RESPONSE TO COMMENTS RECEIVED ON THE DRAFT NEGATIVE DECLARATION

PHILLIPS 66 LOS ANGELES REFINERY PROPOSED CRUDE OIL STORAGE CAPACITY PROJECT

COMMENT LETTERS RECEIVED ON THE DRAFT ND AND RESPONSES TO COMMENTS

Figure F-2

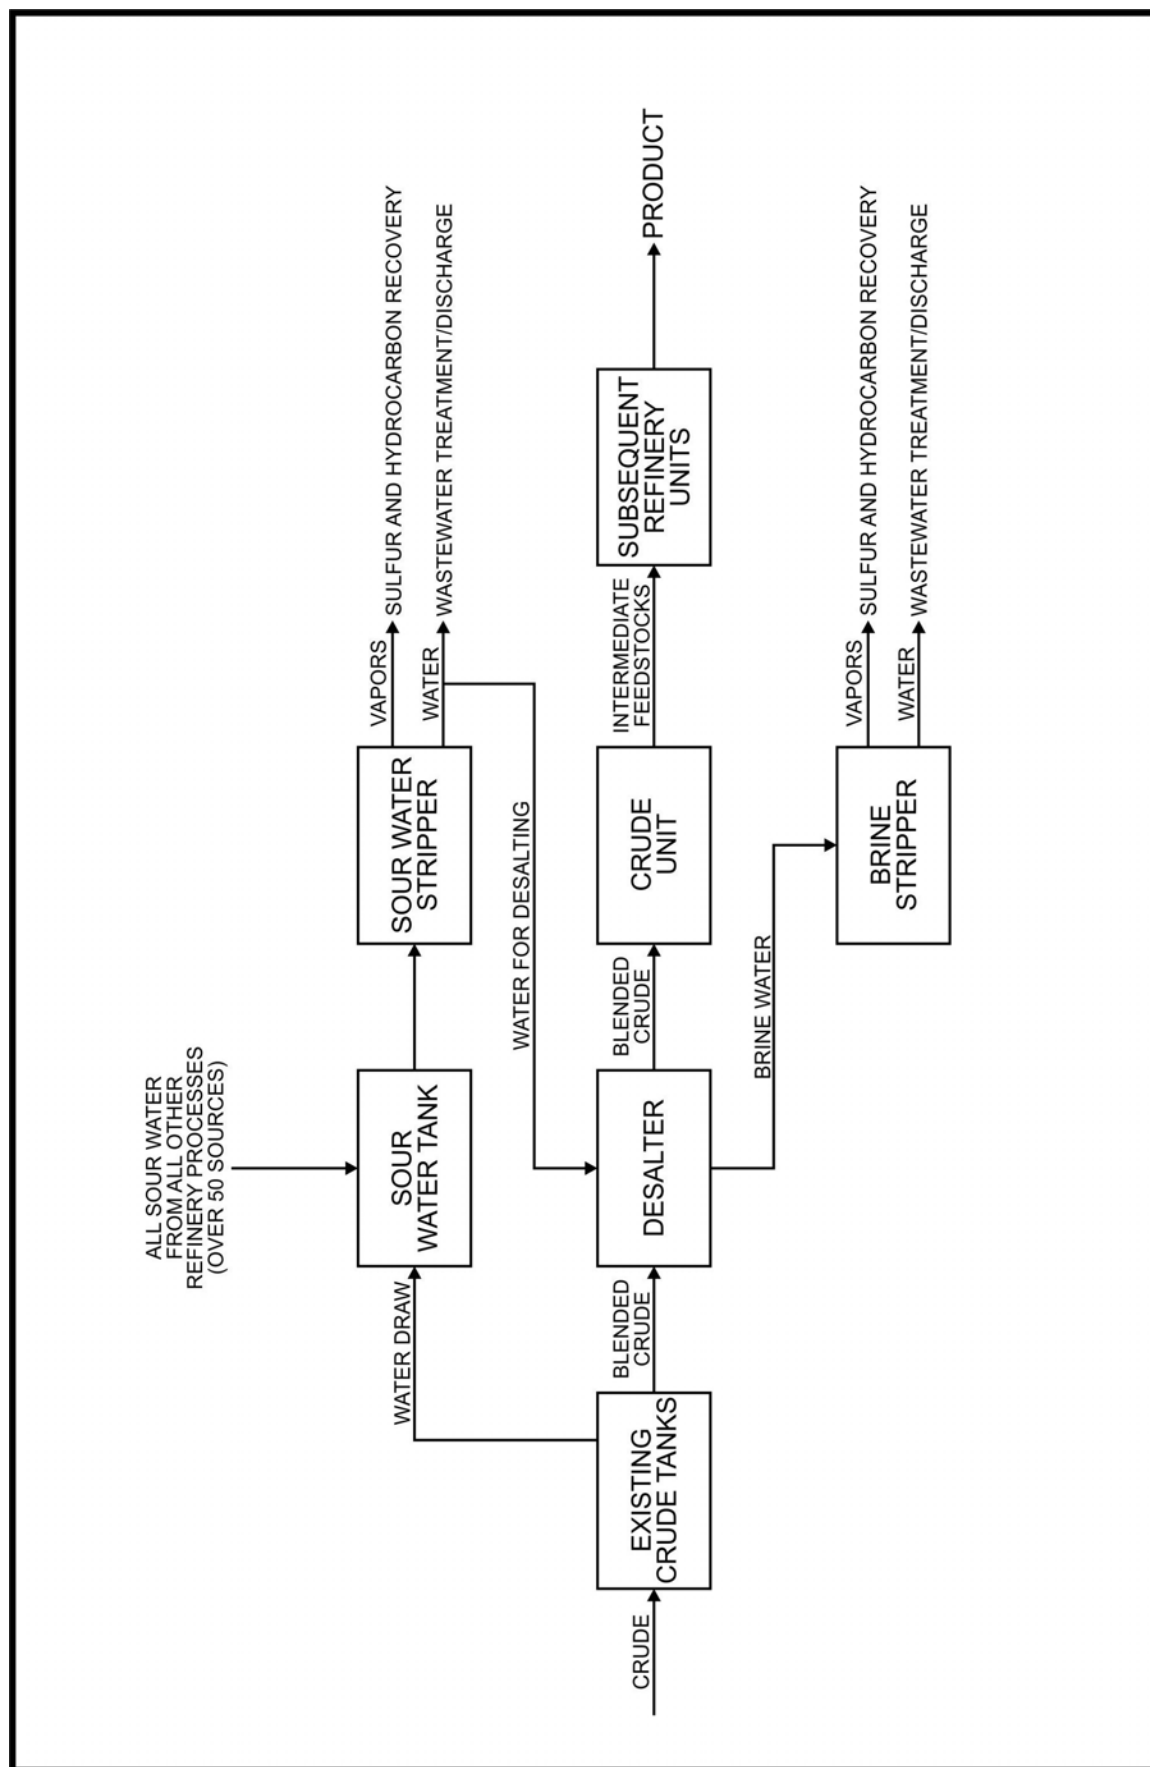
The existing configuration of the crude oil storage tanks, Desalter Unit, and Crude Unit are depicted in Figure F-2. This figure also shows the two wastewater treatment units: the Sour Water Stripper and the Brine Stripper. Crude oil stored in tanks is routed to the Desalter Unit for removal of salts and water prior to being fed to the Crude Unit. Some of the water present in crude oil is separated by gravity in storage tanks, and forms a water layer below the crude oil in the tank (since water is heavier than oil). This water layer is periodically removed from the storage tank and is termed the “water draw”. Currently, the water draw from existing storage tanks is routed via the sour water tank to the Sour Water Stripper. The sour water tank currently stores sour water³ recovered from units throughout the refinery. The Sour Water Stripper removes sulfur and hydrocarbon vapors from the wastewater.

The Desalter uses partially treated water from the Sour Water Stripper as wash water to remove salts such as calcium chloride, magnesium chloride, and sodium chloride from the crude oil feed.

As previously explained in Responses 2-9 and 2-10, the Brine Stripper currently receives water from the Desalter and the proposed project would reroute water draw from storage tanks into the Brine Stripper. These operations, as shown in Figure F-3, are on a separate process stream than the Crude Unit and subsequent refinery units. The purpose of the Brine Stripper is to remove any residual crude oil from the wastewater prior to discharge and does not “desalt” as implied in this comment. As also discussed in Response 2-10, the reference to the industry paper (provided by the commenter as Exhibit A) is not relevant to the proposed project, as the existing Desalter and crude oil heat exchangers associated with the Crude Unit are not a part of the proposed project, are separate equipment from the proposed project, and will not be altered by the proposed project.

Figure F-3

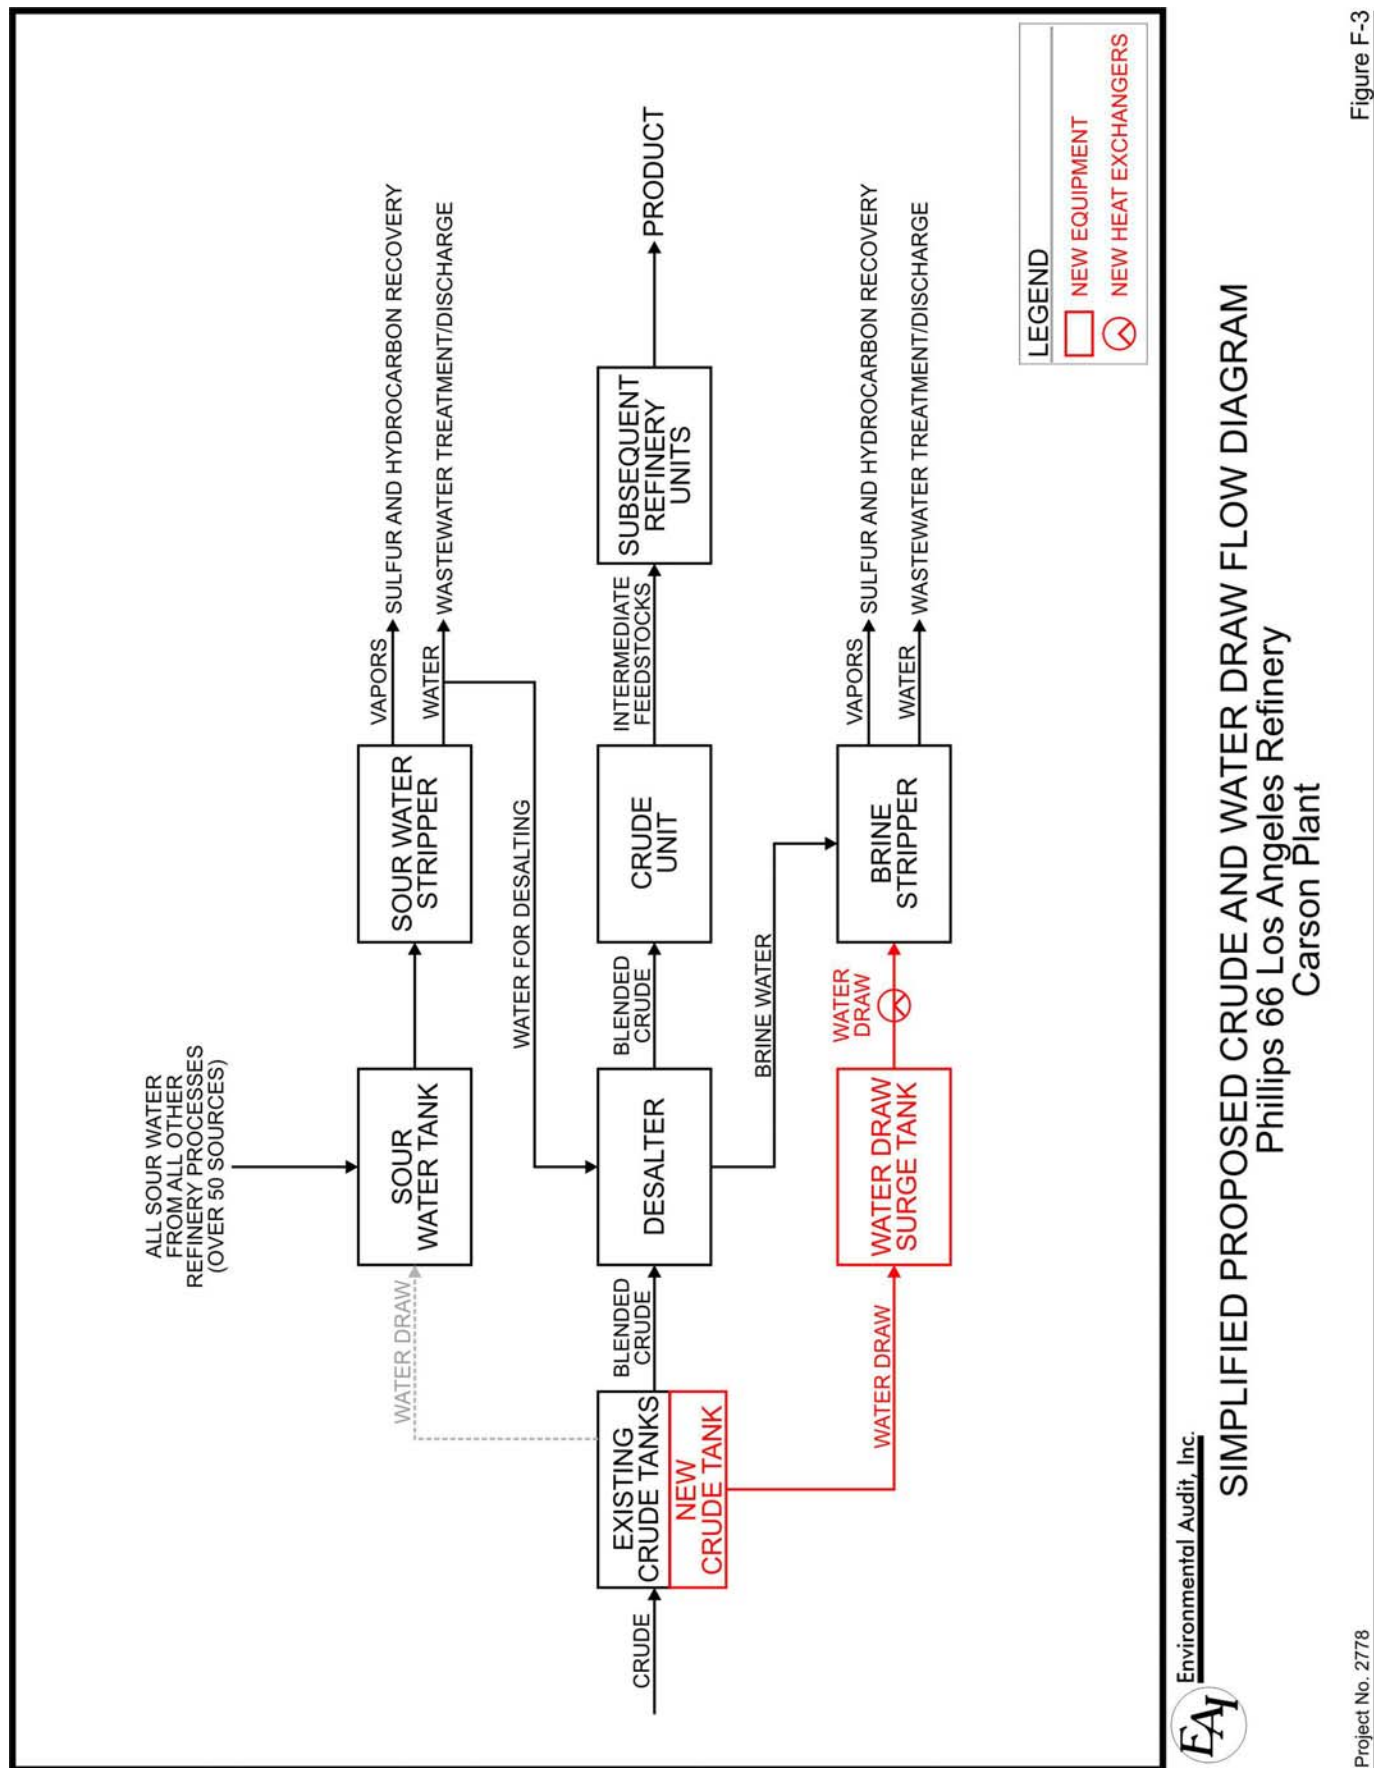
The proposed configuration, as well as new equipment, is depicted in Figure F-3. In this diagram the new crude oil storage tank is shown, as well as the new water draw surge tank. The water draw stream from both the existing crude oil storage tanks and the proposed new crude oil storage tank is proposed to be routed to the Brine Stripper. New heat exchangers are also proposed, to ensure that the water draw stream is at the proper feed temperature for Brine Stripper operation as discussed in Response 2-3. Note that the heat exchangers are being added between the water draw surge tank and the Brine Stripper parallel to the wastewater from the Desalter, and thus the heat is not used to heat the crude oil, nor used in the processing of the crude oil.

Further, the reference to the industry paper (provided by the commenter as Exhibit A) is not germane to the proposed project because the paper focuses on heat exchangers for crude oil upstream of a Desalter, and no changes to crude oil heat exchangers or the operation of the Desalter are part of the proposed project (see Figure F-3). The industry paper discusses the heating of stored crude oil before it is fed to a desalter and ultimately to a crude unit. The proposed project will not make any changes to: (1) the existing heaters associated with Crude Unit operations; (2) any heat exchangers that would heat crude oil; or (3) the Desalter. Therefore, the concerns raised in the article do not apply to the proposed project. The proposed project will install three new heat exchangers for the purpose of heating wastewater from the water draw surge tank before it is fed to the Brine Stripper so the water can be at the proper temperature for processing in the Brine Stripper, a wastewater pre-treatment unit upstream of the main LARC wastewater treatment system. The proposed project will not alter the Desalter or Crude Unit in any manner. As discussed above, the new heat exchangers will be included in the fugitive components associated with Tank 2643, which is a separate permitted process than the Desalter and Crude Units and associated fugitive components. The new fugitive components will be incorporated into the Rule 1173 monitoring program, which is audited by the SCAQMD.
